Watts Bar Nuclear Plant, Unit 2  
NRC Docket No. 50-391

**Subject: WATTS BAR NUCLEAR PLANT (WBN) UNIT 2 – REQUEST FOR  
ADDITIONAL INFORMATION (RAI) GROUP 6 REGARDING “FIRE  
PROTECTION REPORT” (TAC NO. ME3091)**

### **Response to NRC's Round 5 Request for Additional Information Regarding "Fire Protection Report"**

**Simplified Sketch of the HPFP System**

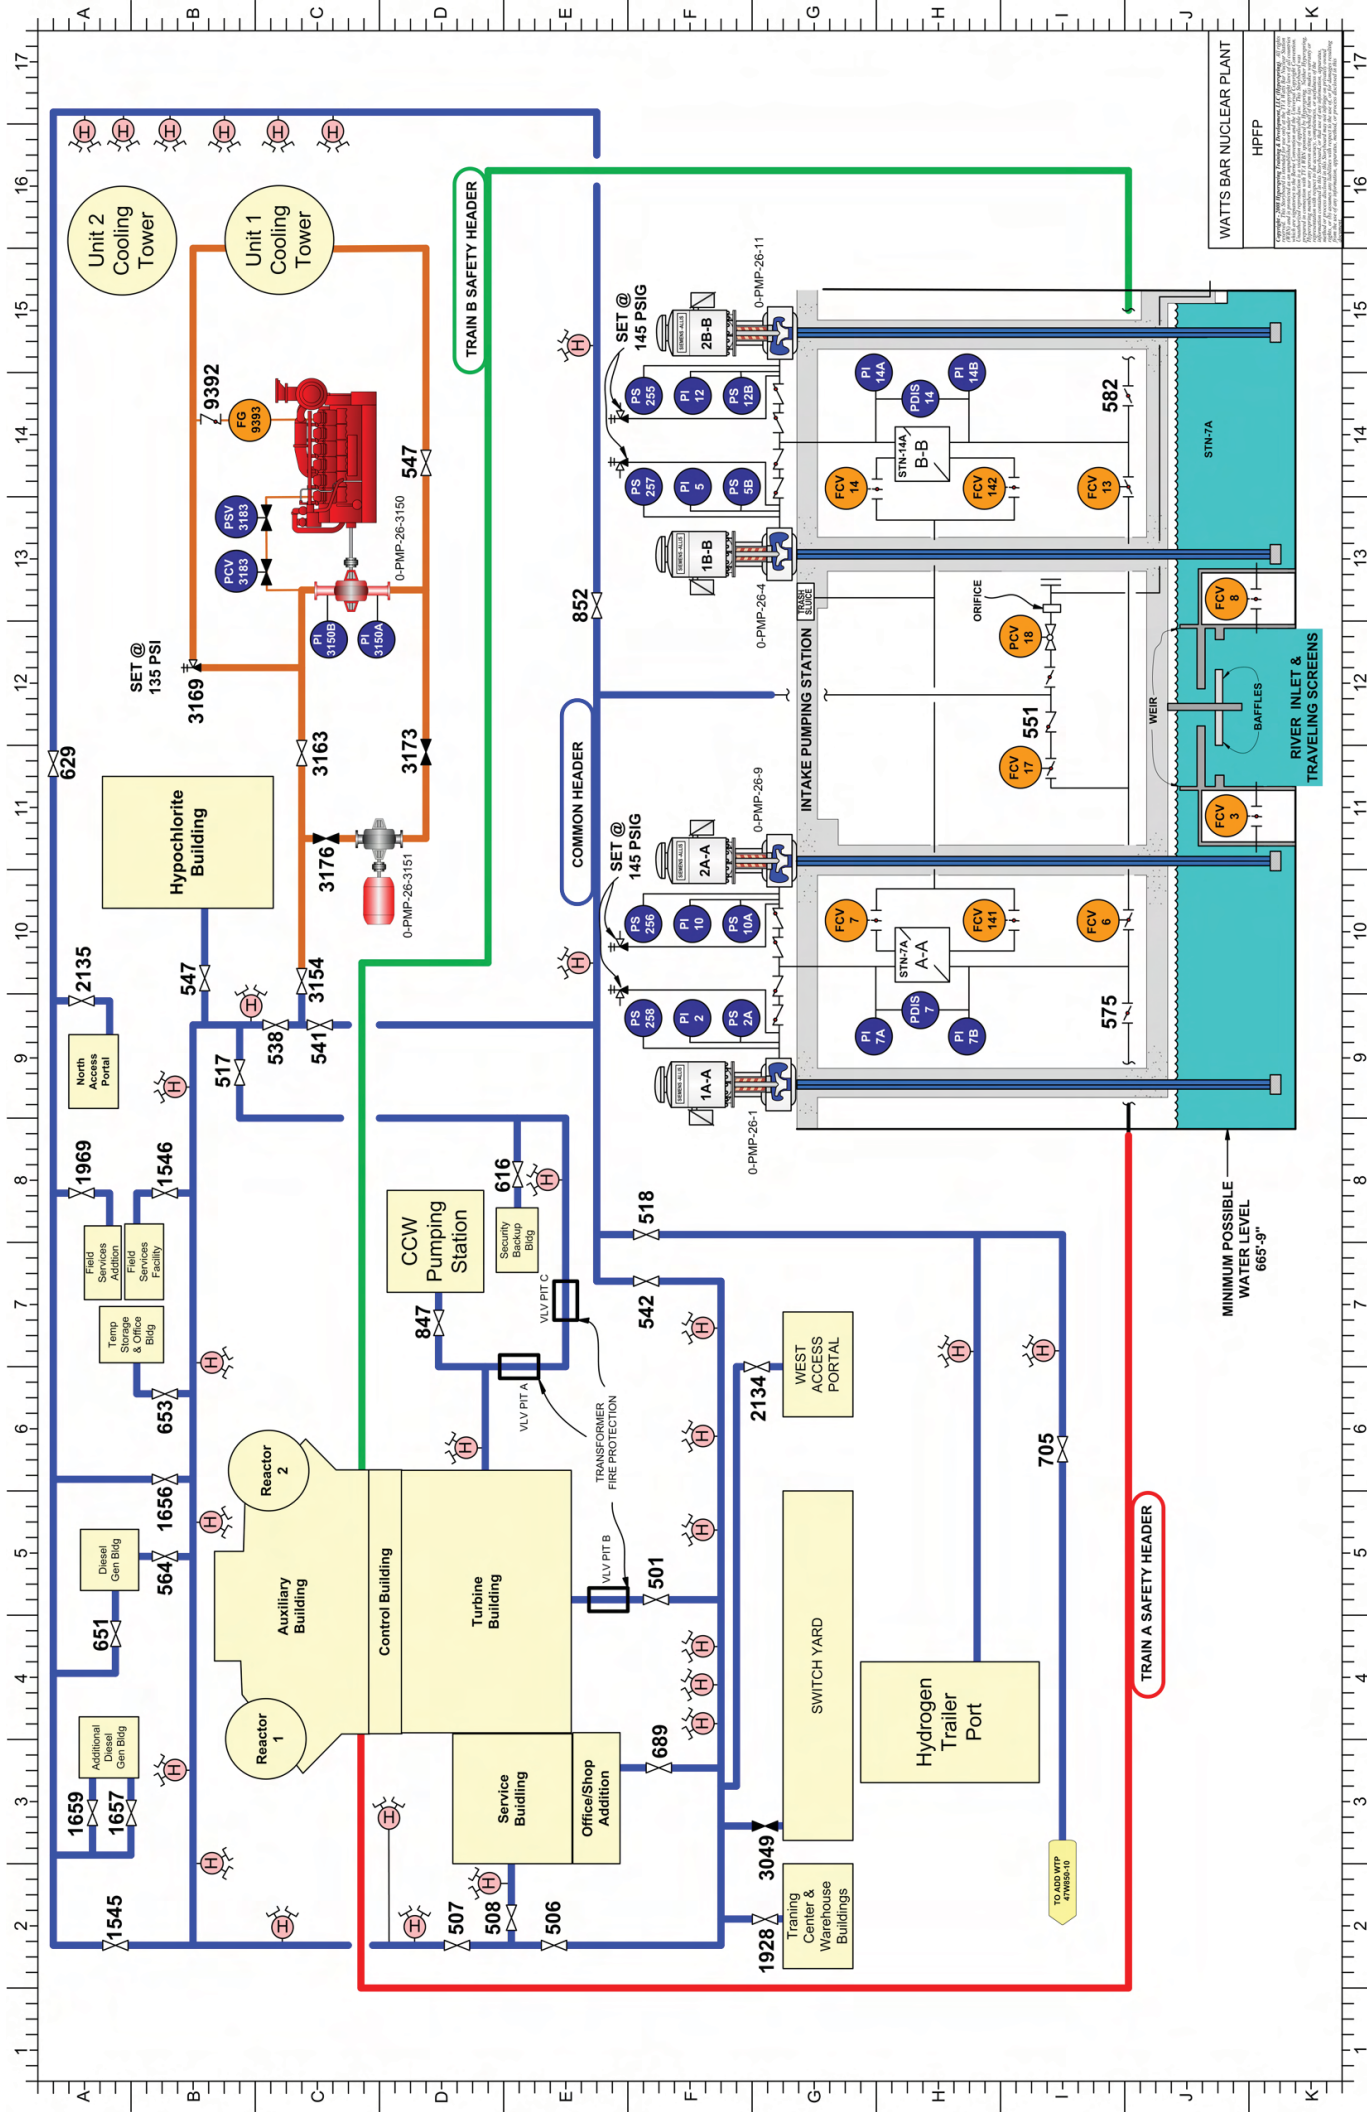
*[1] Provide a detailed description of the high pressure fire protection system configuration. The description should include, but not be limited to the following:*

Attached is a simplified sketch of the majority of the HPFP system. This sketch does not show the loop that serves the Training Center and the warehouses to the north of the Protected Area. The A train, the B train, and the main common headers are shown. In addition, there is a loop inside the Turbine Building and a loop inside the Auxiliary Building. The Turbine and Auxiliary Building loops are intertied in two diverse locations at the interface of the Turbine and Auxiliary Buildings. The Turbine Building loop is connected to the yard loops at two locations and has one connection to the Service Building. During normal operation, the system is interconnected with all sectionalizing valves open.

During the design bases flood, sectional valves are closed to ensure the Train A and B headers are established to support the safety function of the fire protection system to provide Auxiliary Feedwater. The buried trained headers enter the Auxiliary Building on opposite sides and connect to the Auxiliary Build HPFP header loop. When the sectional valves are closed for flood mode, the ties to the Turbine Building are isolated and the supply from the buried trained headers is sectionalized to A train and B train and both can supply Auxiliary Feedwater.

1. The demineralized water purification process (shown on the Figure II-45.A as "ADD WTP") is located in the yard such that the feed is via Turbine Building to yard to ADD WTP.
2. The main HVAC loads are in the Service Building and the Main Office Building, and the feed is via Turbine Building to Service Building.
3. One HVAC load in the Control Building is fed by the Turbine Building loop.
4. The auxiliary boiler feed pump seal cooler is fed by the Turbine Building loop.
5. The as-needed service water connections are fed via the Turbine Building through the yard loops to the individual buildings.
